1966 Corvette: Service Bulletin: Air Pump Noise - Air Injection Reactor System

Subject: Air Pump Noise - Air Injection Reactor System

Model and Year: 1966 Corvette

Bulletin No: TSB #66-62

Date Code

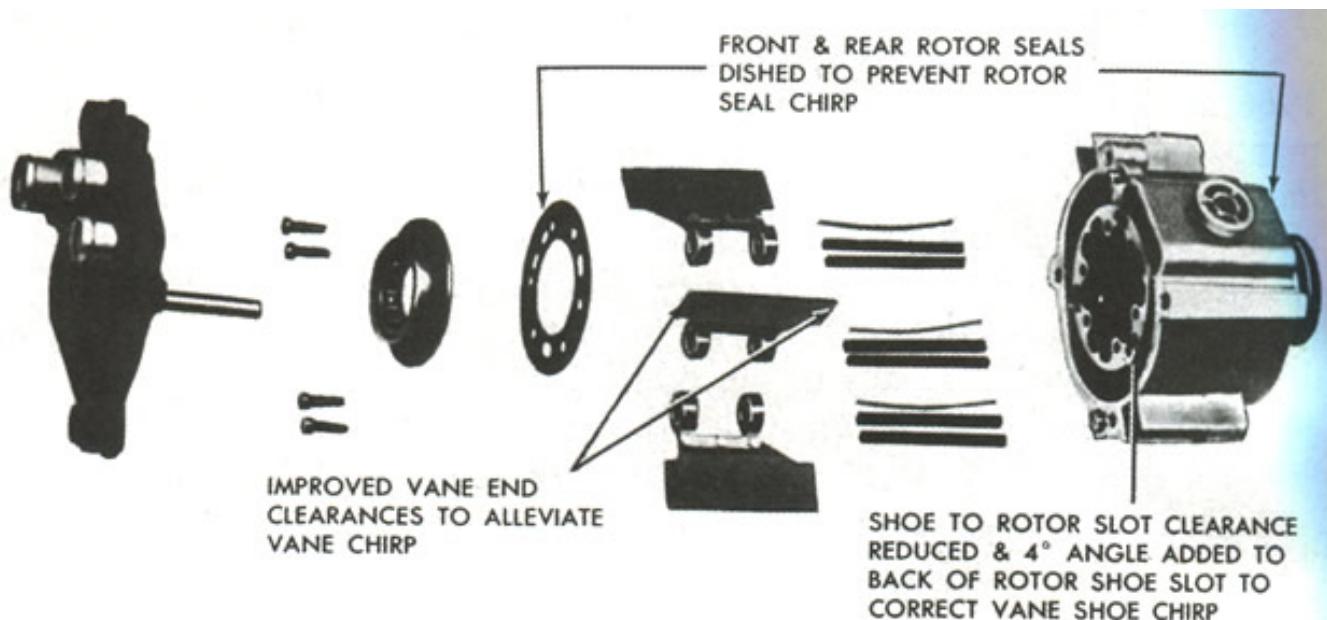
An objectionable "chirping" noise in the air pump may be noted on early units equipped with an Air Injection Reactor System. This noise may be due to the vane ends rubbing the housing and the rear cover, vane shoe vibration, and/or vibration of the rotor seals under light back pressure conditions.

In production, beginning with date code 0126XX stamped on the pump housing, improvements have been incorporated as noted on page 2, to alleviate the above conditions.

If the "chirping" noise is most noticeable at idle speeds and is intermittent, it

may be corrected by increasing the pump idle speed or by allowing additional wear-in time. if this fails, the pump must be disassembled and the vane ends lightly touched with emery cloth.

If upon completion of the above, the "chirp" still persists, or if the "chirp" is heard at higher pump speeds, the entire pump assembly must be replaced with a pump having a date code of 0126XX or later. Control of pump service components is such that there is no identifying feature to indicate the latest improvements.

Oil should not be injected into the pump to correct "chirp" since the bearing grease will become diluted and failure will result.
